Volvo Steering Shaft Recall Fact Sheet

Models: 2016 and 2017 Volvo VNL, VNM, and VNX Models with a 2-piece steering shaft.

Build Dates: May 11, 2015 through March 8, 2016.

Figure 3

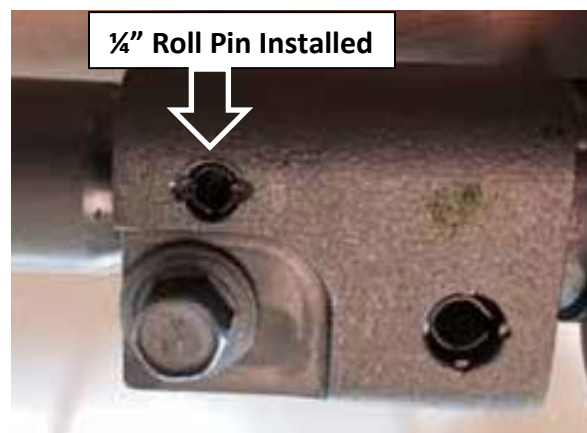
Interim Fix: Volvo has identified an interim fix which involves drilling an additional hole, and inserting a ¼ inch roll pin. If this solution is applied, the truck is safe to operate and is **NOT** to be placed out-of-service. A picture of the interim solution is shown below (Figure 3):
